RE: Nos. 110-114 Herring Road, Macquarie Park - Section 75W Modification of MP10_0112 Concept Plan Approval and MP 10_0113 Stage 1 Project Approval (MOD 5)

This letter has been prepared to respond to Council's email to the Department of Planning on 26 February 2015. Council's email indicates their support of MOD 5, which amends the plans to comply with the PAC determination of 21 November 2015 (MOD 3).

**Re: Section 75W Application relating to 110-114 Herring Road, Macquarie Park
Concept Plan Modification (MP10_0112 MOD 5) and Stage 1 Project Approval
Modification (MP10_0113 MOD 5)
Traffic Statement – Design of Traffic Elements**

FIGURE 1 – STORAGE CAGES

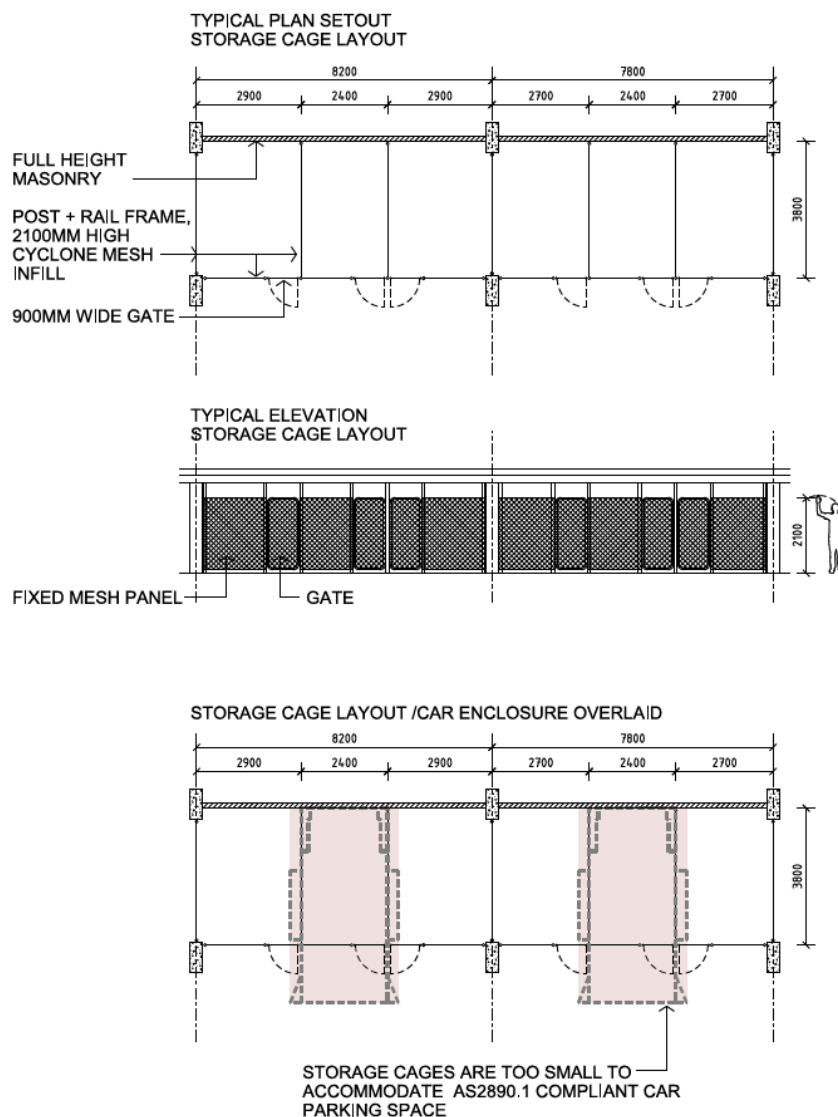
2 Detailed plans to show how storage areas will not be capable of conversion to parking

Under the Australian Standards *AS/NZS 2890.1:2004 Parking Facilities - Off-Street Car Parking*, the minimum car space requirement is 2400mm by 5400mm, or an internal width of 3000mm for enclosed car spaces. The cages are enclosed by a full height masonry rear wall and cyclone mesh dividing wall. A 900mm wide door provides access to the cages, rather than a full width garage door.

The storage areas range in width from 2400mm to 2900mm. All spaces have a maximum length of 3800mm. The storage cages would therefore not comply with the minimum width and length required for enclosed spaces (refer to Figure 1).

The dimensions for the 85th percentile vehicle under the *AS/NZS 2890.1:2004* is 4910mm by 1870mm. Even if the cages were removed the space is not of a sufficient size to accommodate a standard medium size vehicle. We note that removal of the cages would be in breach of the approval.

A 'small' car space should be 5000mm by 2300mm (unenclosed). This requirement is based on what is referred to as a 'light' car. The dimensions of such a vehicle are 4450mm in length and 1700mm in width and this represents the 35th percentile vehicle. The storage cages are not long enough to accommodate even a small vehicle.

Drawing Title
LEVEL B1 PLAN

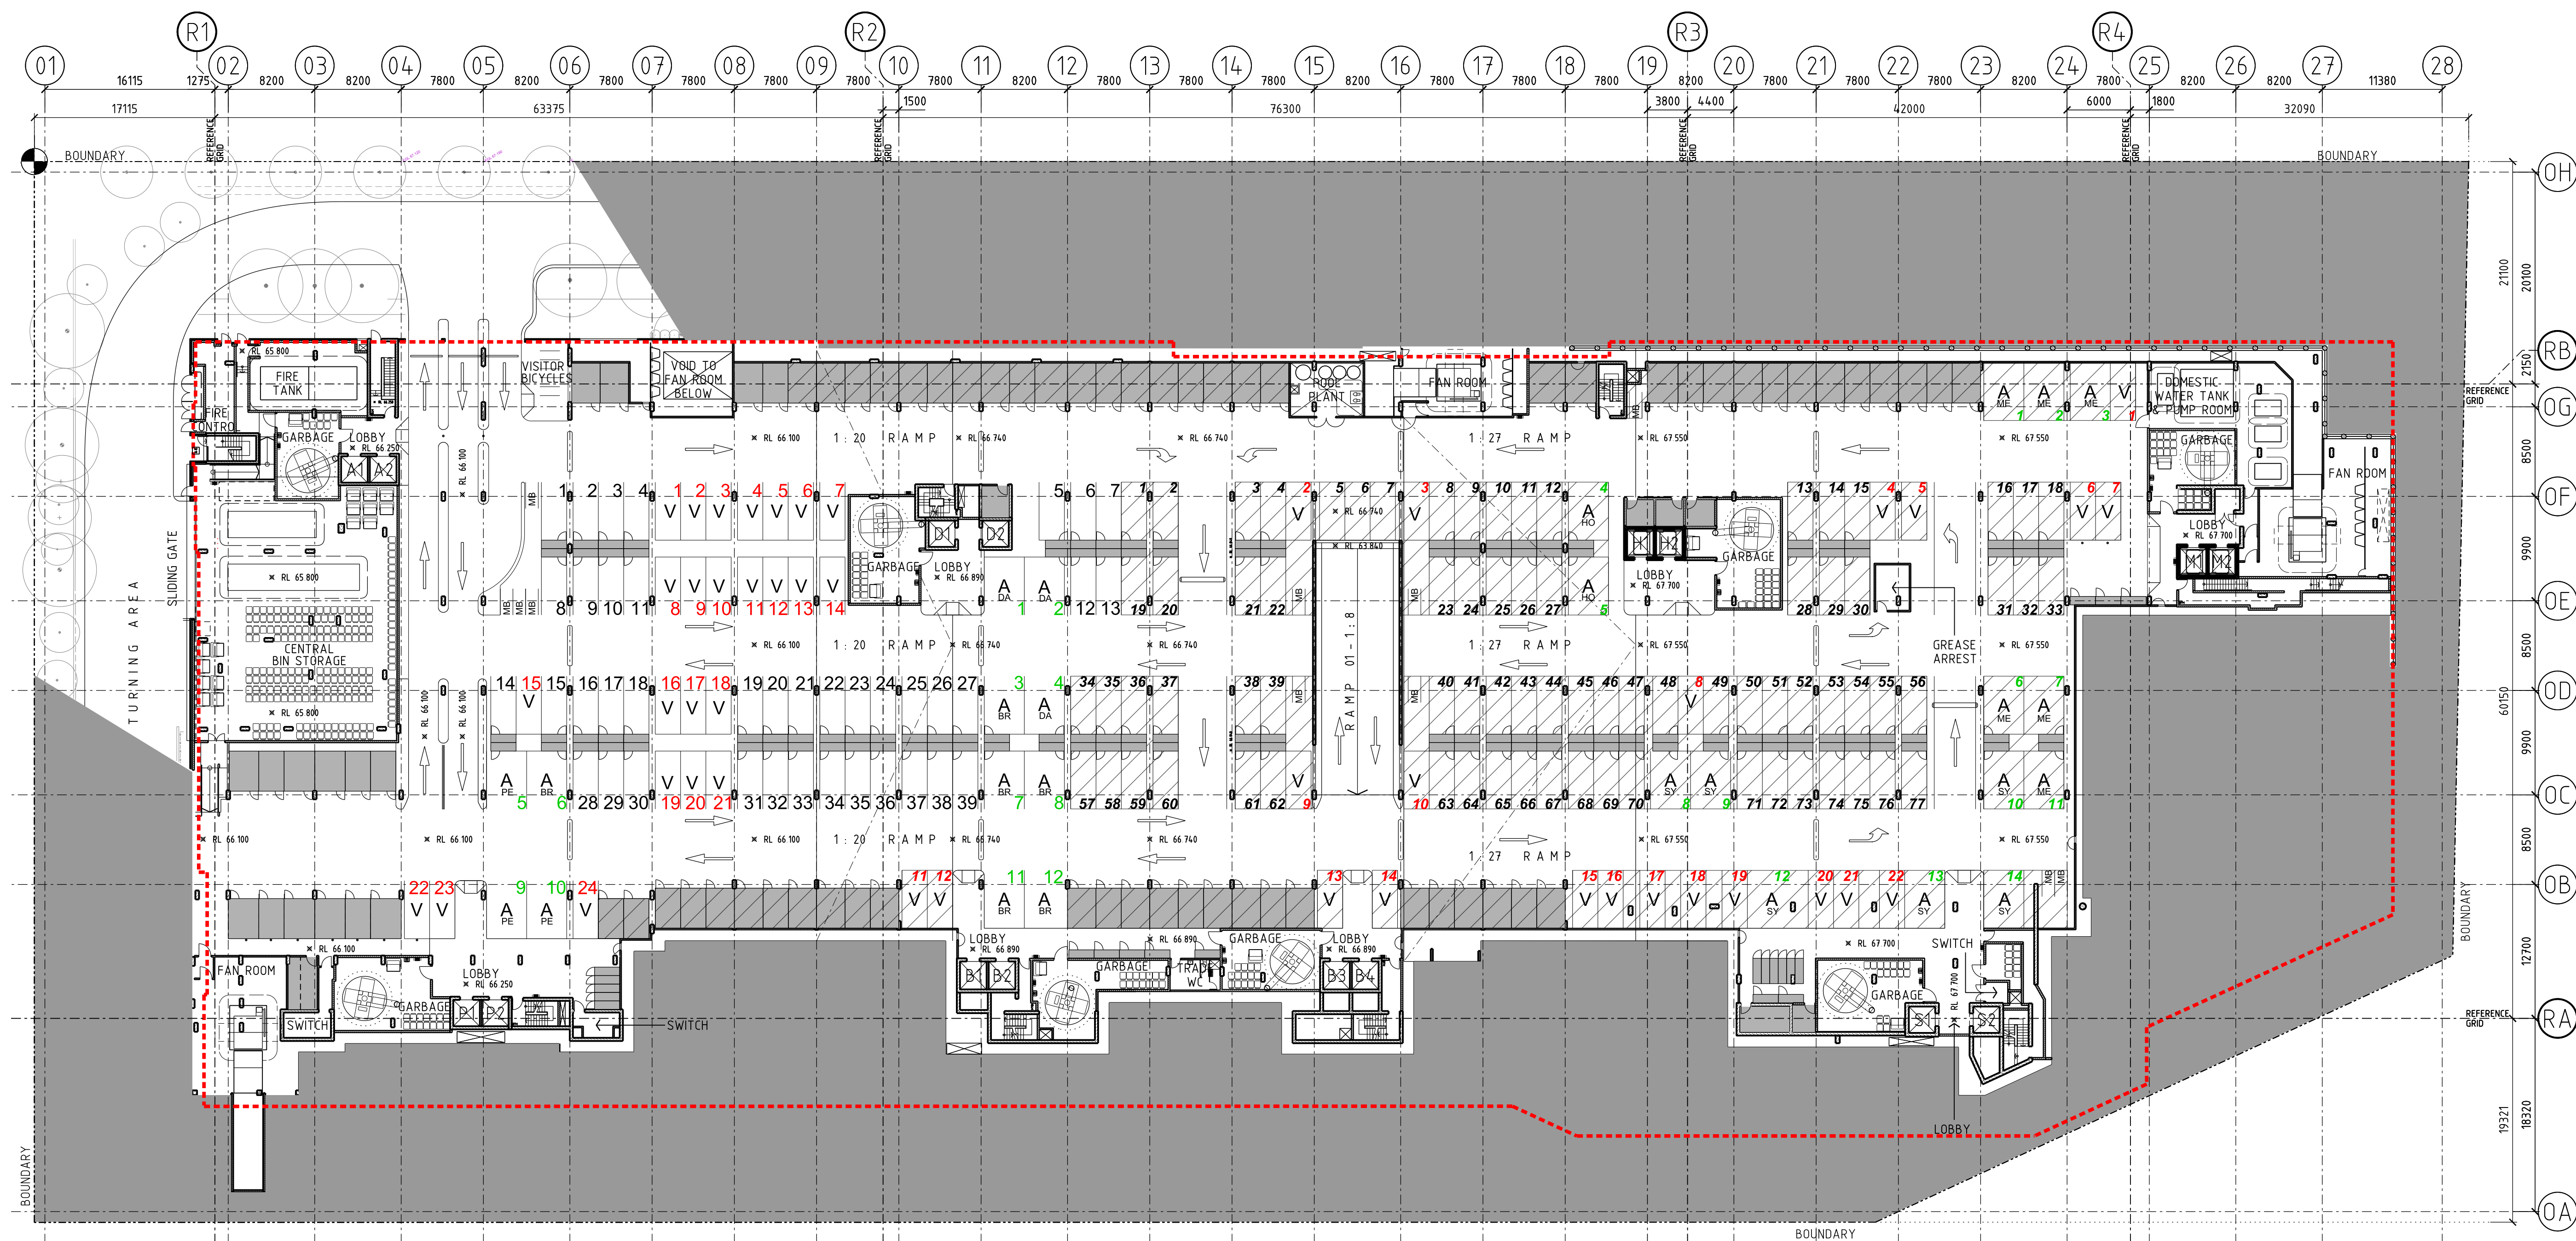
- *The bin storage area on the western end of the basement has been deleted and there is no facility for trucks to pull up.*

- *There is no clean-up room/ hard waste storage area of 20m² for household clean up. This needs to be accessible by truck from the loading area.*

- *Basement needs to be a minimum of 4m high for trucks to enter.*

- *The carousel compactor will not work. It needs to have 1,100L bins for this size of development.*

Response: This is incorrect. A central bin storage area is proposed on the western side of the basement. There is also a loading dock area for trucks to pull up and service the bin store through a sliding gate on the western elevation.

Response: A hard waste storage area is now clearly indicated on the drawings. The area is a designated space within the main bin storage room, separate to the car park area. The hard waste area is 10m² and is considered to be sufficient for the development and consistent with Part 7.2 of Council's DCP, which requires a separate room or undercover caged area of a minimum 5m² for developments of 30 or more dwellings.

Response: The basement has a minimum 4.5m clearance for truck access.

Response: 1100l bins are proposed on the carousel.

Accordingly, the matters raised in the RFI and Council's further items have been addressed, as per DA Drawing Nos. 2001, 2002 and 2003 Revision H.

Drawing Title
LEVEL B2 PLAN

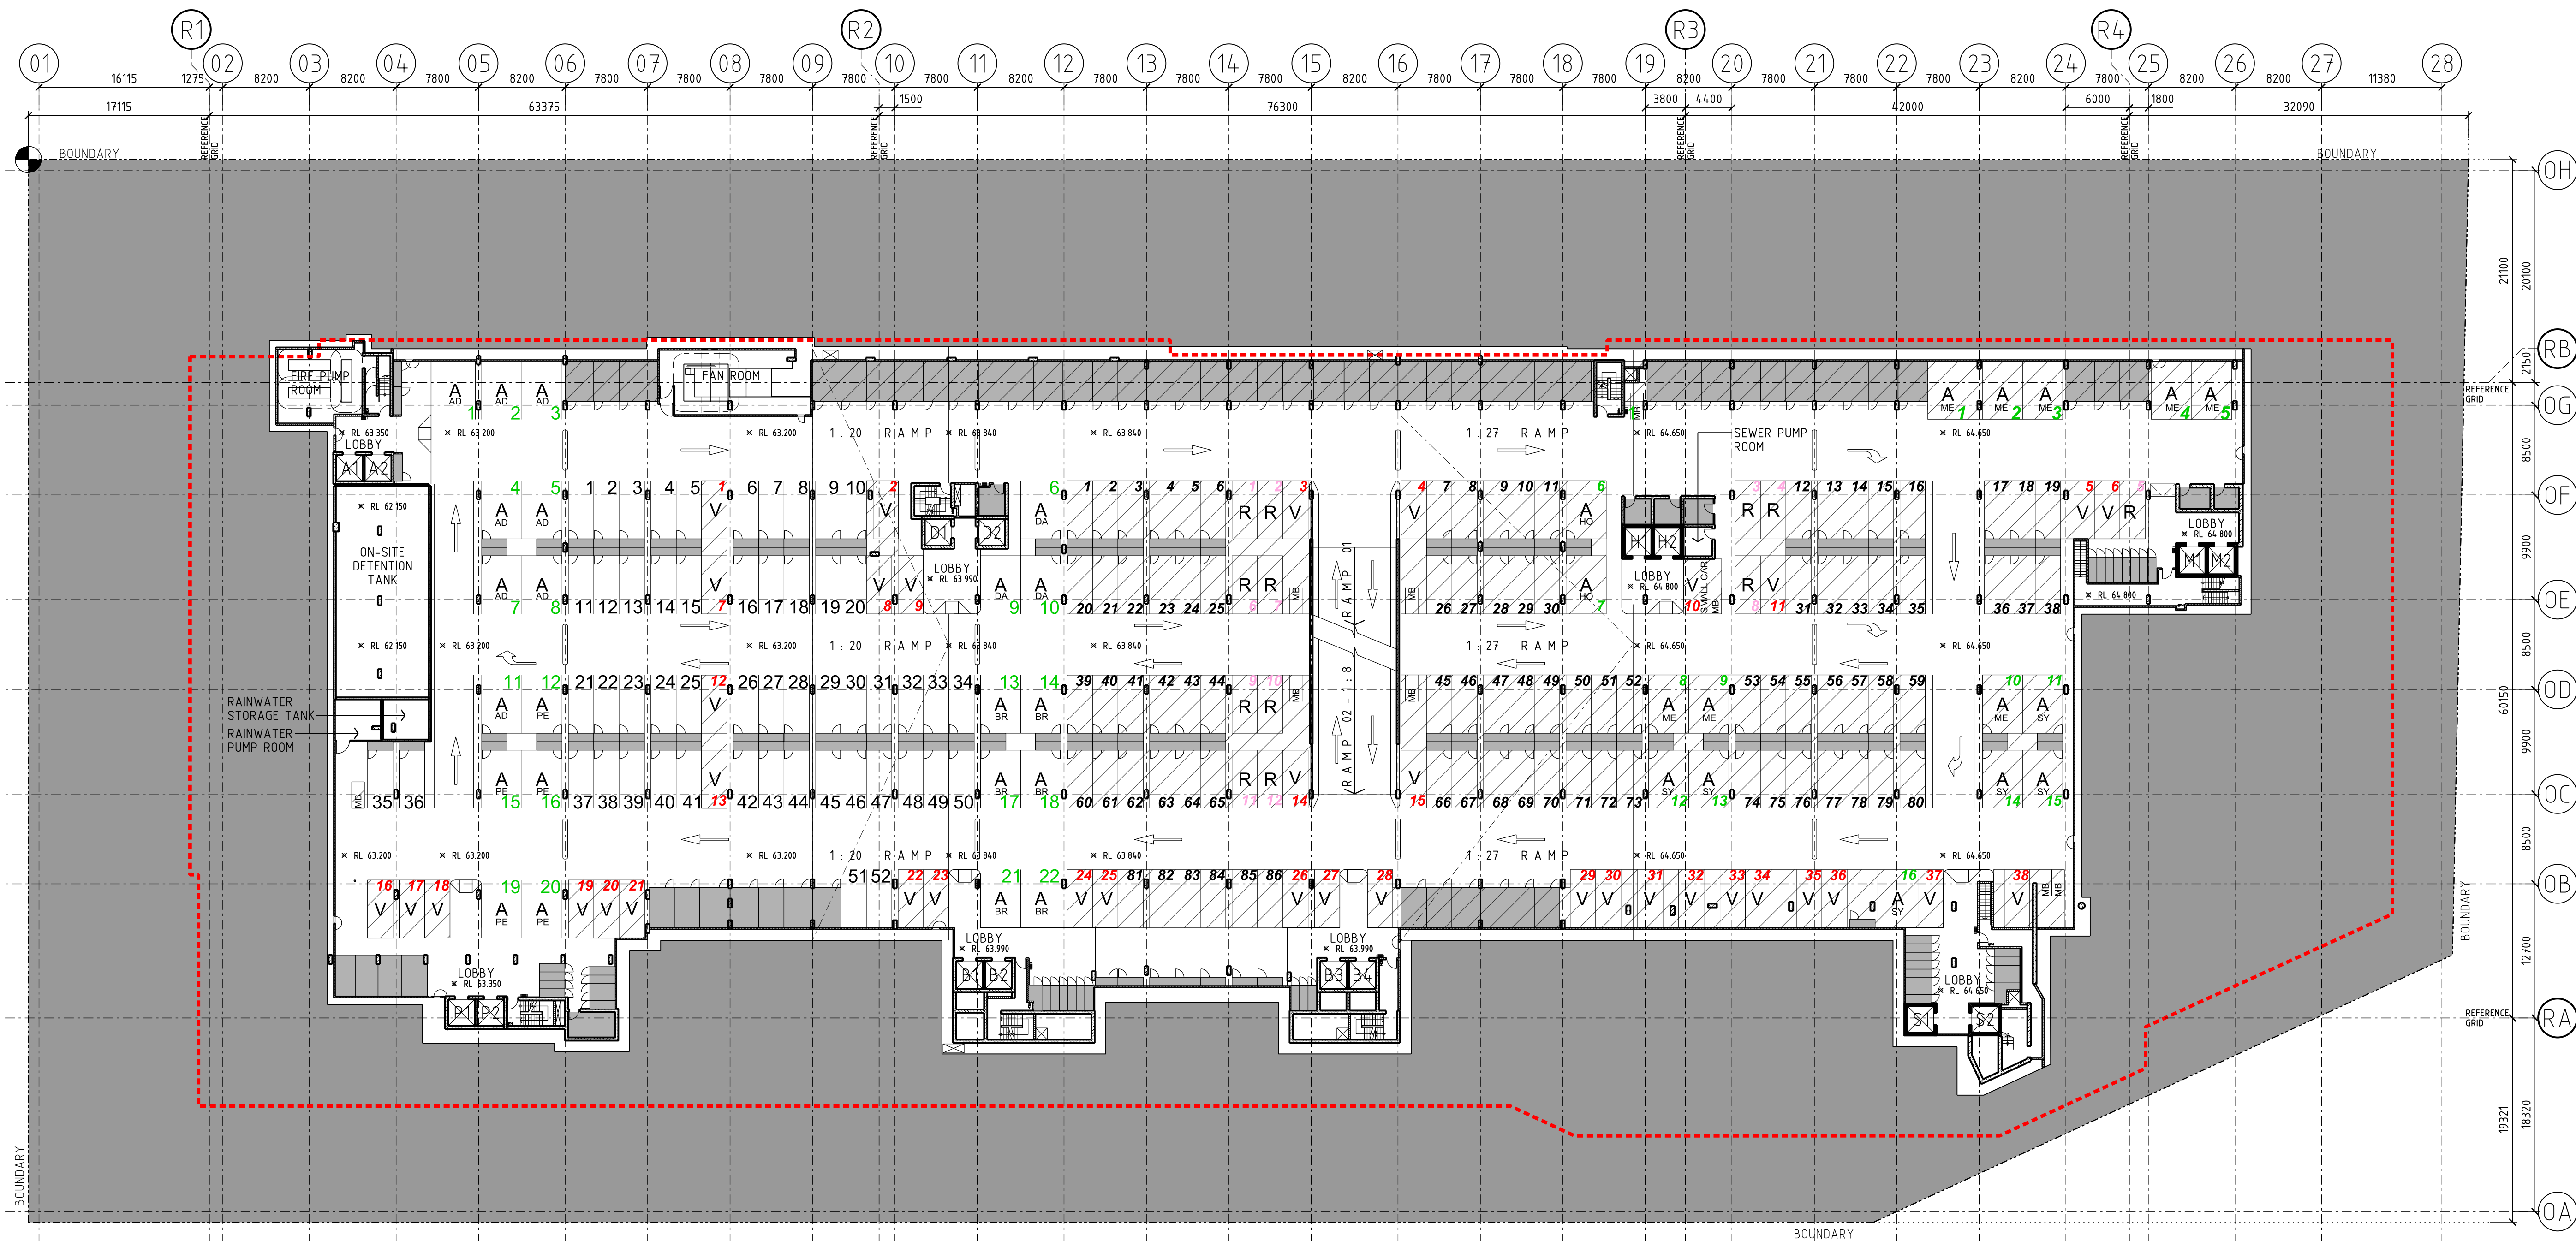
Council has requested more information to confirm that the car parking complies with relevant standards, including layout, driveway grades, clearances, and is functional in terms of security separation of areas, service vehicles.

As shown the architectural drawings included as **Attachment A**, the internal car parking design, including ramps, internal circulation aisles, parking aisles and parking modules, is generally in accordance with the requirements of AS2890.1, AS2890.2, AS2890.6 and AS4299, as summarised following:

- Standard parking spaces are a minimum of 2.4m wide and 5.5m long, exceeding the minimum requirements as stipulated in AS2890.1 (Clause 2.4.1) for User Class 1A spaces;
- Parking aisles are a minimum of 5.8m wide, meeting the minimum requirements as stipulated in AS2890.1 (Clause 2.4.2) for User Class 1A parking facilities;
- Grades across parking spaces do not exceed 1:20, noting that AS2890.1 (Section 2.4.6) permits grades across parking spaces of up to 1:16 in any direction other than parallel to the direction of the parking spaces (Clause 2.4.6);
- Columns are positioned so as to not impede vehicle manoeuvring into and out of parking spaces, or opening of doors, in accordance with the AS2890.1 (Clause 5.2);

- Where parking spaces are adjacent to walls or other vertical obstructions outside the clearance envelope around parking spaces as required under AS2890.1 (Figure 5.2), a minimum 300mm clearance area is provided adjacent to these spaces.

- Accessible parking spaces are 3.8m wide and 5.5m long, in accordance with the requirements of AS4299 (Clause 3.7).
- Motorcycle parking spaces are 1.2m wide and 2.5m long, in accordance with the requirements of AS2890.1 (Section 2.4.7).

- 1m aisle extensions are provided at blind aisles, in accordance with the requirements of AS2890.1 (Section 2.4.2).
- Ramps are proposed to have a maximum grade of 1:8, which meets both the maximum grade and the maximum grade change requirements as stipulated in AS2890.1 (Clause 5.5.3); and

- A minimum height clearance of 2.2m is to be provided throughout the car park as required under AS2890.1, with 2.5m clearance to be available above accessible parking spaces in accordance with the requirements of AS2890.6.
